**SUBJECT: COMANCHE PEAK NUCLEAR POWER PLANT, UNITS 3 AND 4
DOCKET NUMBERS 52-034 AND 52-035
SUPPLEMENTAL INFORMATION IN RESPONSE TO THE REQUEST FOR
ADDITIONAL INFORMATION REGARDING THE ENVIRONMENTAL REVIEW**

Supplemental Information in Response to the Request for Additional Information Regarding the Environmental Review

QUESTION NO.: GEN-03 (3.6.1-1) HYD-23 (9.4.2.2.5-1) and LU-03 (5.5.1.1.2-1)

Figure 3.6-1 Sketch of Blowdown Water Treatment Facility Per Unit

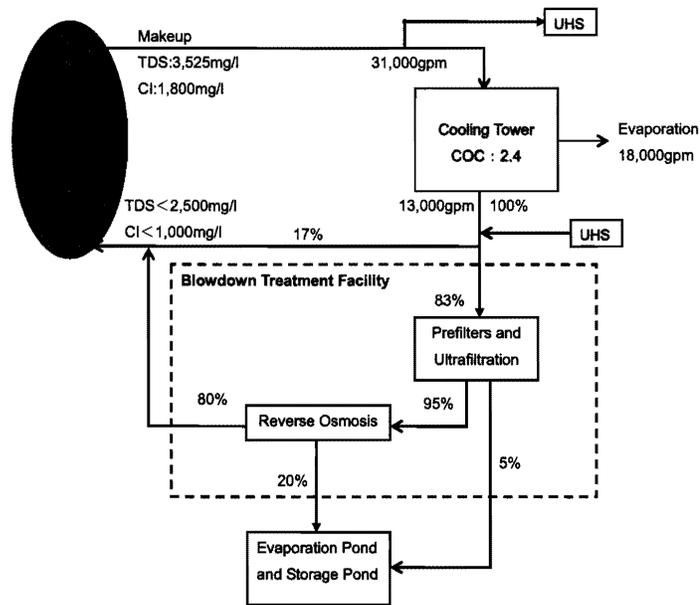
For the discussions below, refer to Figure 3.6-1. The normal flow path of BDTF at the design conditions will take approximately 83 percent of the blowdown flow and divert it to the facility for treatment. Approximately 95 percent of the diverted water is filtered water and will be sent to the R/O unit. Approximately 80 percent of the filtered water will become treated water and will be reverted back to the main blowdown stream. Approximately 5 percent of the diverted water is reject water from the filters and approximately 20 percent of the filtered water is reject water from the R/O units. The reject water above will become waste water, which will be backwash containing the rejects from pre-filters, ultrafilters, and R/O membranes and will be routed either directly to the misters or the storage pond. If there are insufficient misters available (due to maintenance) to evaporate the total amount of design flow, the excess will be diverted to the storage pond and then be sent to the misters when load demand improves. New Subsection 3.6.1.4 that discusses the BDTF flow process has been added to the ER.

The pre-filters reduce turbidity and the ultrafilters remove colloidal materials from cooling tower blowdown water. The function of the R/O membranes is to concentrate the TDS, chloride, and metals by a factor of five (5). R/O membranes are designed to achieve 80 percent recovery with clean R/O permeate of approximately 8200 gpm. The waste reject concentrate is approximately 2040 gpm from the R/O membranes. The total discharge is approximately 2600 gpm including backwash water (approximately 540 gpm) to the evaporation pond.

For the discussions below refer to Figure 3.6-1. The normal flow path of BDTF at the design conditions will take approximately 83 percent of the blowdown flow and divert it to the facility for treatment. Approximately 95 percent of the diverted water is filtered water and will be sent to the

Figure 2
Objects in RiverWare Model

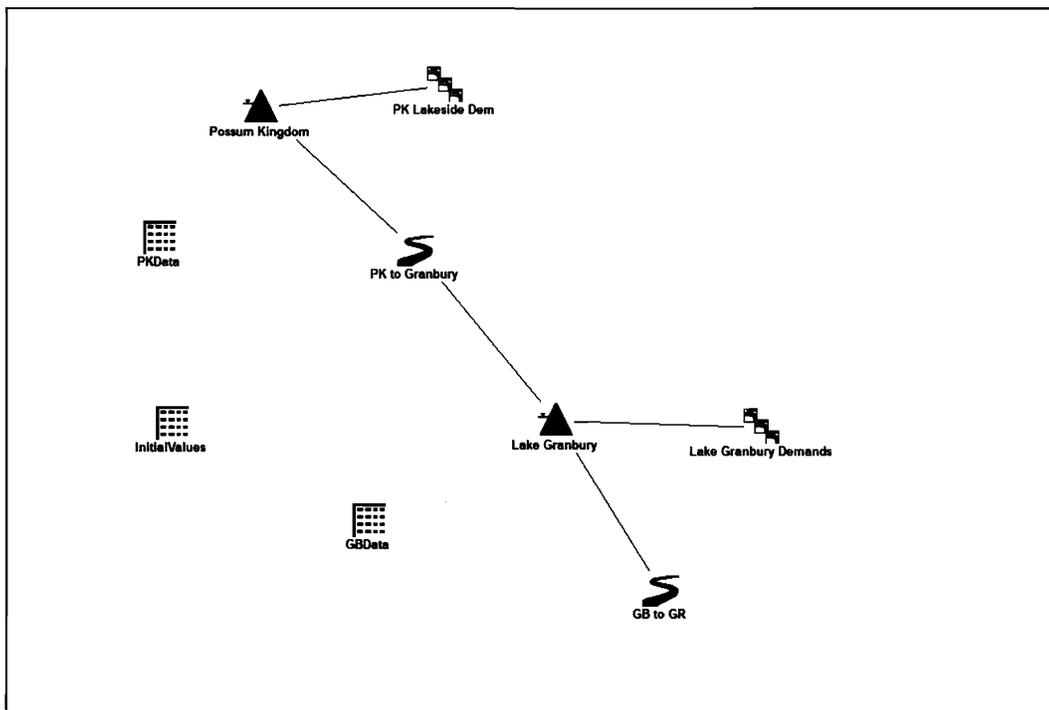
4. The Lake Granbury Dissolved Minerals Study used a RiverWare model of the Brazos River from Lake Possum Kingdom to the Brazos River near Glen Rose stream gage (USGS 08091000), including Lake Granbury. Figure 2 shows the objects in the RiverWare model. The Glen Rose gage is located 4.1 stream miles upstream of the confluence of the Brazos and Paluxy Rivers¹. The modeling to date does not extend to the Paluxy confluence. The RiverWare model uses monthly hydrology covering the historical period from 1940 to 2007. Attachment 1 contains more information regarding the model.

Figure 3
Simulated Lake Granbury Elevations
Scenarios A and C - 2020 Conditions

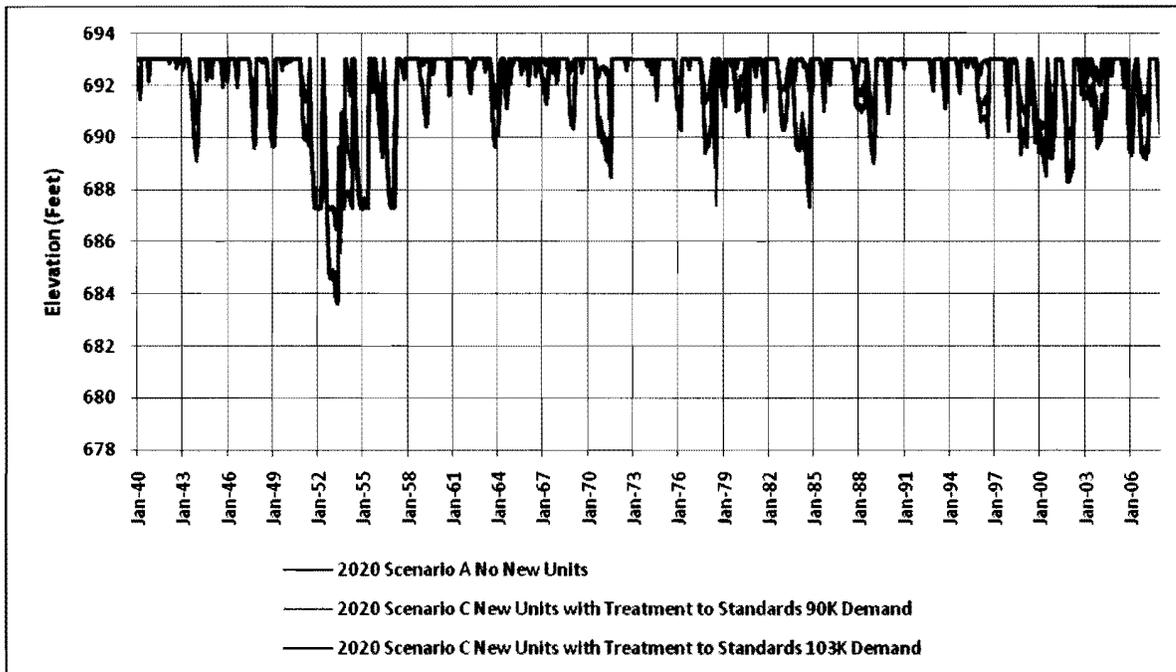
5. Figure 3 compares the simulated elevations in Lake Granbury for Scenarios A and C under 2020 conditions. Scenario A is shown in blue. Scenario C includes demands at both 90,152 (shown in green) and 103,717 acre-feet per year (shown in red). Figure 4 shows the exceedence frequency of the elevations in the same reservoir. Attachment 2 contains tables with the data used to create these graphs. Without the demands for the new units (Scenario A), the reservoir is full about 57 percent of the time. With the new units (Scenario C), Lake Granbury is full about 48 percent of the time at the 90,152 acre-feet per year demand level and about 46 percent of the

Figure 5
Simulated Lake Possum Kingdom Elevations
Scenarios A and C - 2020 Conditions

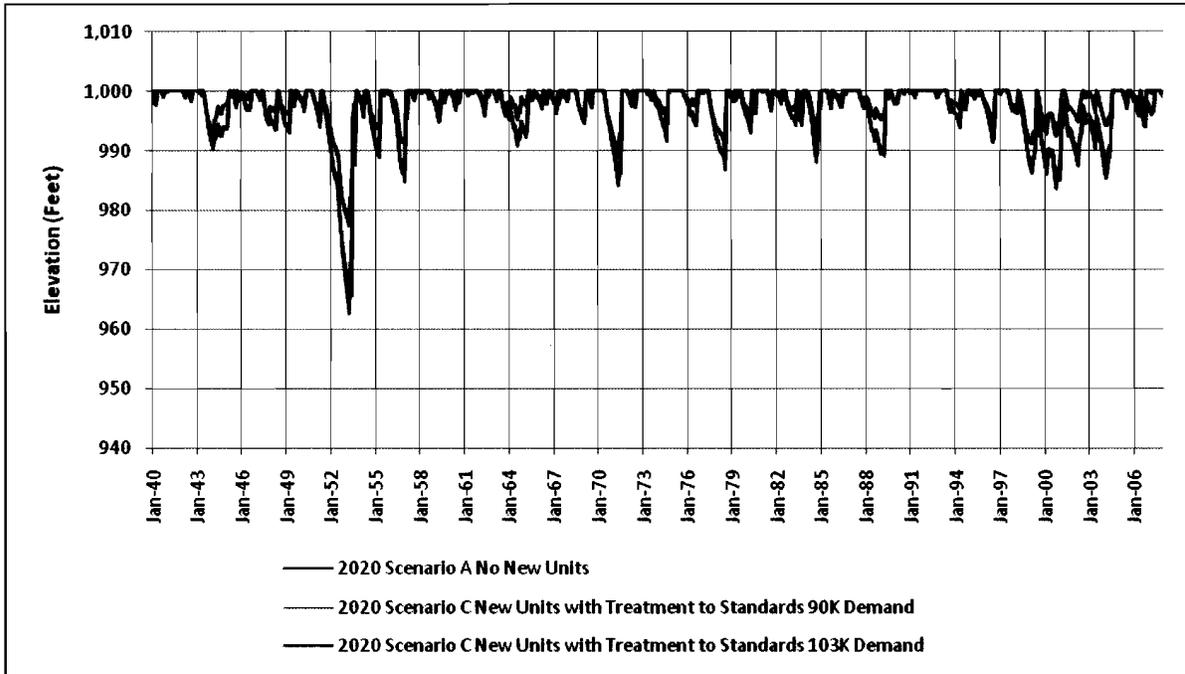
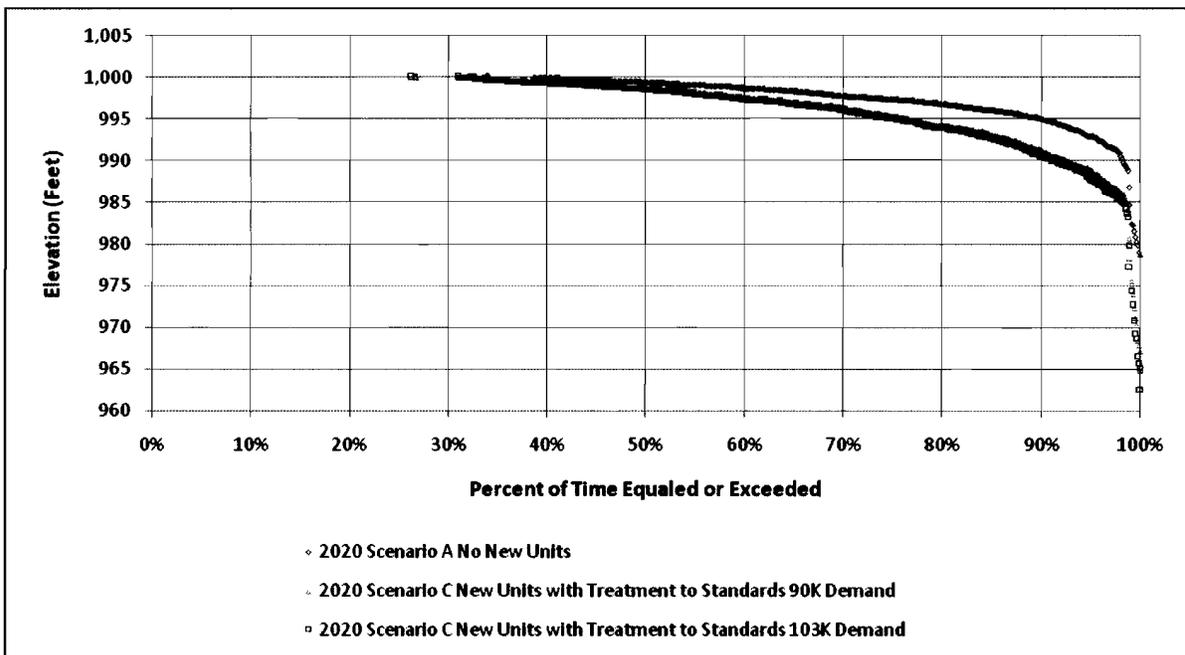
6. Figures 5 and 6 show the simulated elevations and exceedence frequency for Lake Possum Kingdom, respectively. Attachment 2 contains tables with the data used to create these graphs. Without the new units (Scenario A), Possum Kingdom is expected to be full about 34 percent of the time. With the new units, the reservoir is full about 27 percent of the time at the 90,152 demand level and 26 percent of the time at the 103,717 acre-feet per year demand level. At the reservoir's lowest point in April 1953, with units 3 and 4 the reservoir is 12.6 feet lower at the 90,152 acre-feet per year demand level and 14.8 feet lower at the 103,717 acre-feet per year demand level. On average, in Scenario C the reservoir is 1.3 feet lower at the 90,152 acre-feet per year demand level and 1.5 feet lower at the 103,717 acre-feet per year demand level.

Figure 7
Simulated Annual Outflow from Lake Possum Kingdom
Scenarios A and C - 2020 Conditions

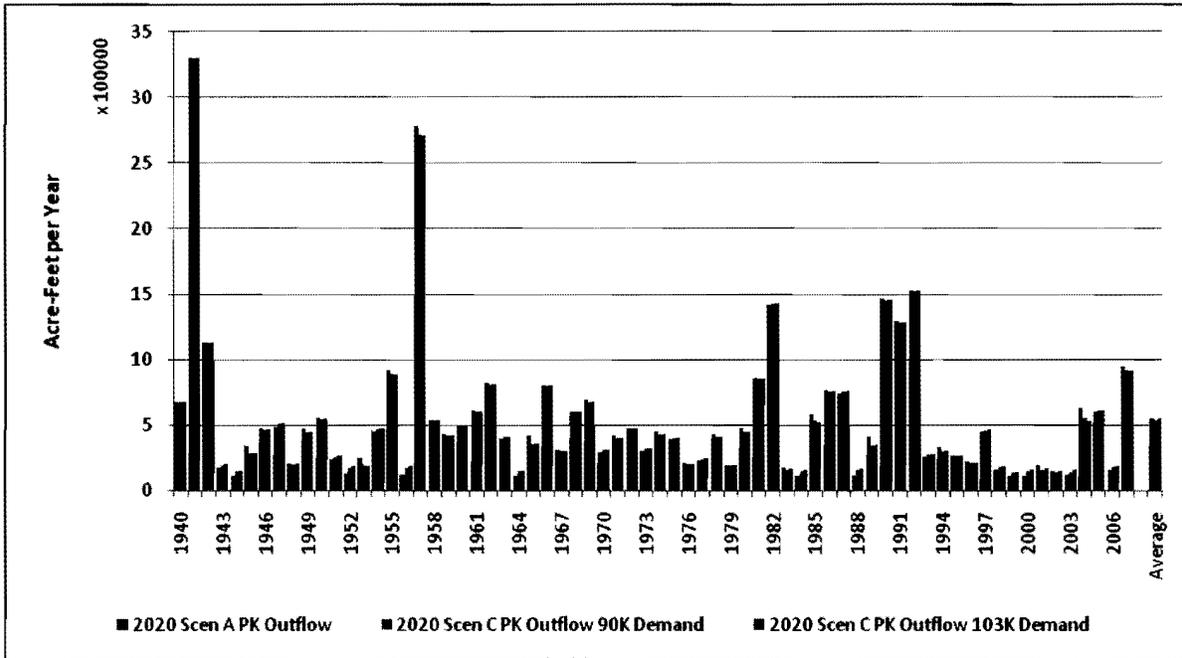
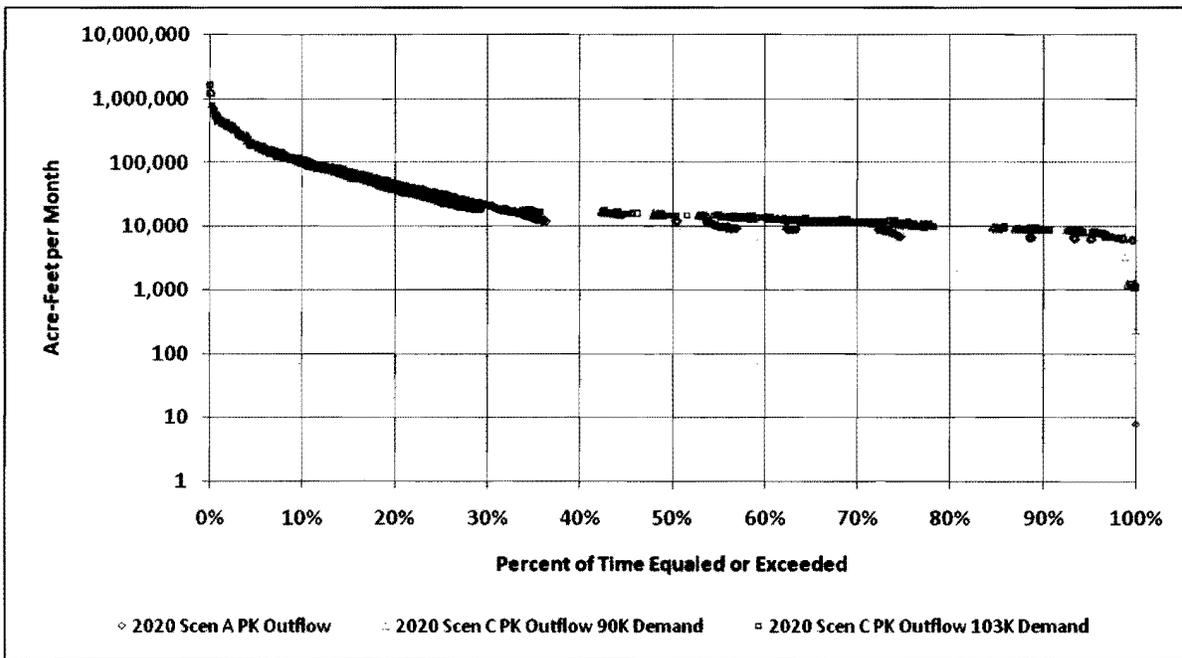
7. Figure 7 shows the modeled annual outflow from Lake Possum Kingdom. Figure 8 shows the exceedence frequency of the monthly outflows from the same reservoir. These values are plotted on a logarithmic scale because of the wide range of values. Figure 9 shows the monthly median outflow from the reservoir. Figures 10, 11 and 12 show the same data for the inflows to Lake Granbury. Attachment 2 contains tables with the data used to create these graphs. These graphs do not show as much difference in flows in this reach as would be expected from the changes in elevation shown in Figures 5 and 6. There are two explanations for this. First, releases from Possum Kingdom when the reservoir is relatively full are similar in both scenarios. Second, the larger spills from Lake Possum Kingdom in Scenario A sometimes mask the increased outflow during dry periods in Scenario C. For example, during the period from July 1951 to April 1953 about 246,000 acre-feet was passed downstream in Scenario A. In Scenario C at the 90,152 acre-feet per year demand level, 338,000 acre-feet was passed downstream during the same period, an increase of 92,000 acre-feet. However, when the reservoir refills in October 1953, in Scenario A 145,000 acre-feet of water spills from Possum Kingdom. In the same month in Scenario C at the 90,152 acre-feet per year demand level, only 37,000 acre-feet spills from the reservoir, a change of 108,000 acre-feet. Even though the outflows are

Figure 13
Simulated Annual Outflow from Lake Granbury
Scenarios A and C - 2020 Conditions

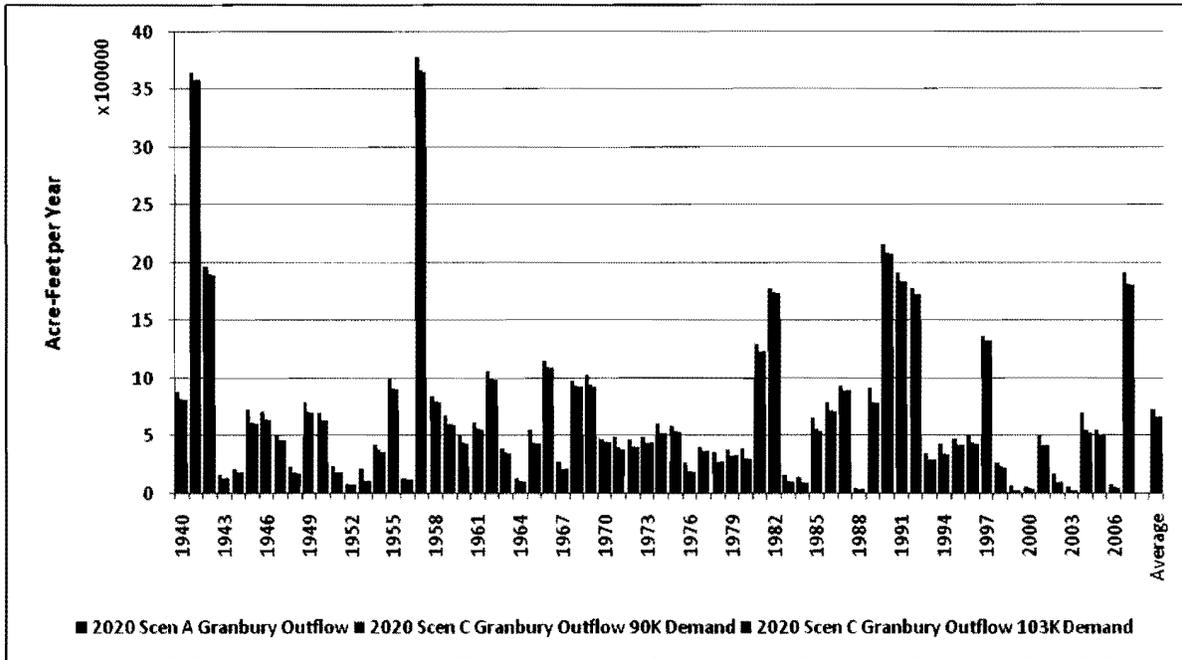
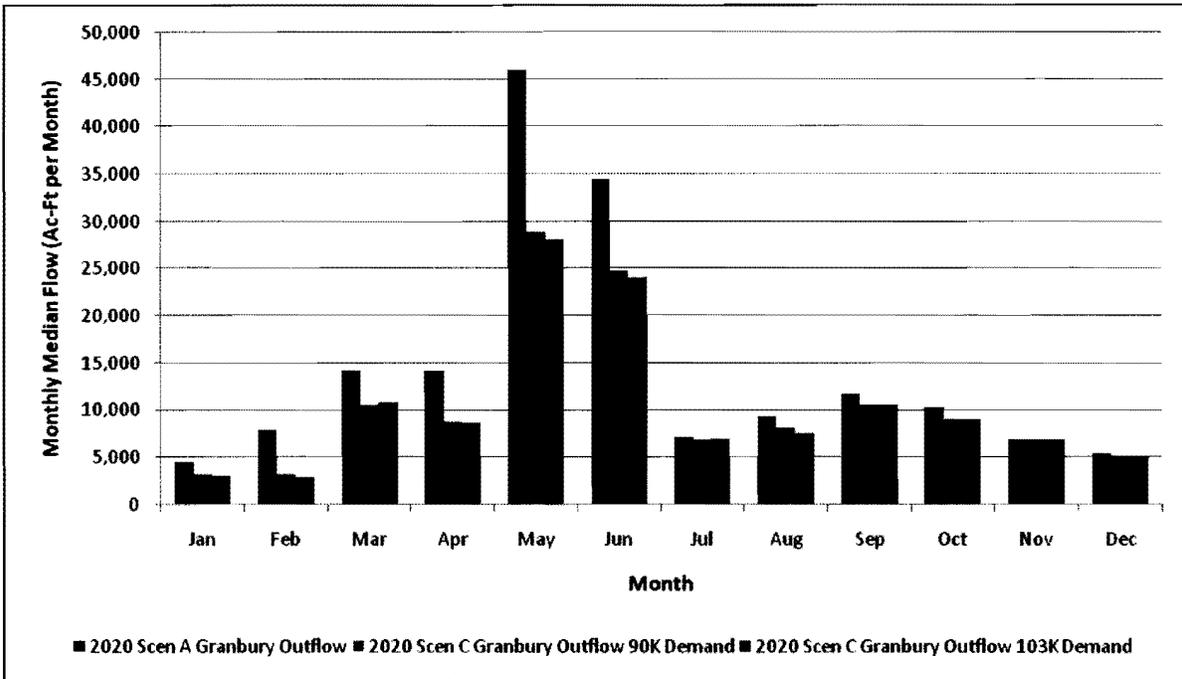
8. Figure 13 shows the annual outflow from Lake Granbury. Figure 14 shows the exceedence frequency of the monthly outflows and Figure 15 shows the monthly medians of the outflows. Figures 16, 17 and 18 show the same data at the Glen Rose gage. Attachment 2 contains tables with the data used to create these graphs. The outflows from Lake Granbury are similar for larger and smaller outflows. As the volume of the outflows decreases, the difference between Scenarios A and C becomes more pronounced, with generally lower outflows in Scenario C (with Units 3 and 4). At the lowest end of the flow range flows are governed by the constant minimum release of 28 cfs. The outflows from the reservoir are similar at both the 90,152 and 103,177 acre-feet per year demands.
